**Valve Adjustment Procedure**

SL12-559/MIKA  
March 2012

GenSet L16/24, L21/31, L27/38

Enclosure:  
Working Card 508-01.10 (14)

Fig. 1

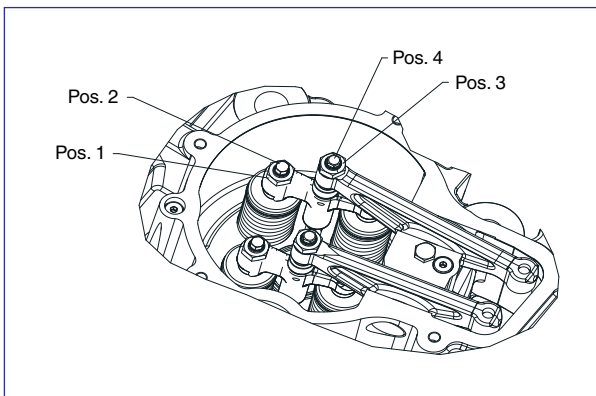
1. Shut-off starting air and fuel oil.
2. Stop the lubricating oil circulation.
3. Dismantle the cylinder top cover.
4. Dismantle the clamp for non-turning bridge, if mounted (L16/24).
5. Turn the crankshaft until the cylinder is in ignition TDC (both valves closed).
6. Check that the surfaces are clean.
7. Loosen the counter nut, pos. 1, and the adjusting screw, pos. 2, on the valve bridge.

Fig. 2

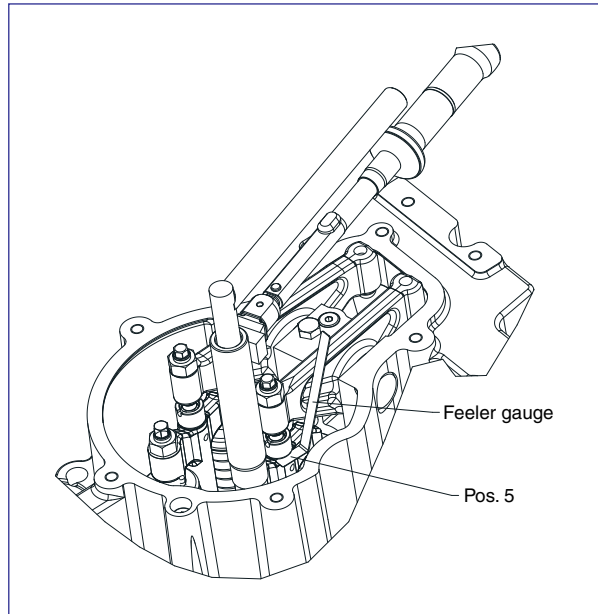
8. Loosen the counter nut, pos. 3, and the adjusting screw, pos. 4, on the rocker arm and insert the feeler gauge between valve bridge and rocker arm, pos. 5.
9. Adjust the screw, pos. 4, on the rocker arm until the feeler gauge makes only slight resistance.
10. Tighten the counter nut, pos. 3, on the rocker arm with torque. Re-check that the feeler gauge clearance has not changed.

Fig. 3

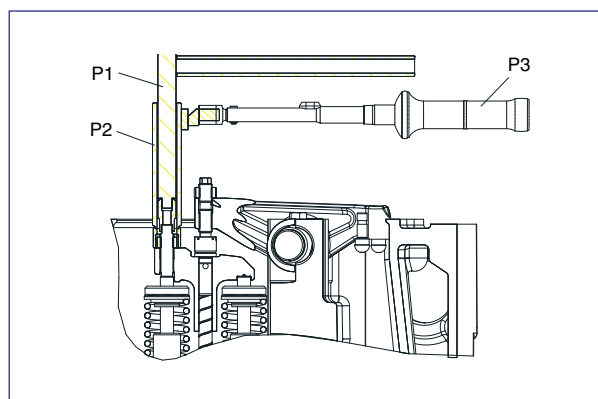
11. Adjust the screw, pos. 2, on the valve bridge until the feeler gauge makes slightly more resistance, but it must still be possible to move the feeler gauge.
12. Tighten the counter nut, pos. 1, on the valve bridge with torque. Re-check that the feeler gauge clearance has not changed.
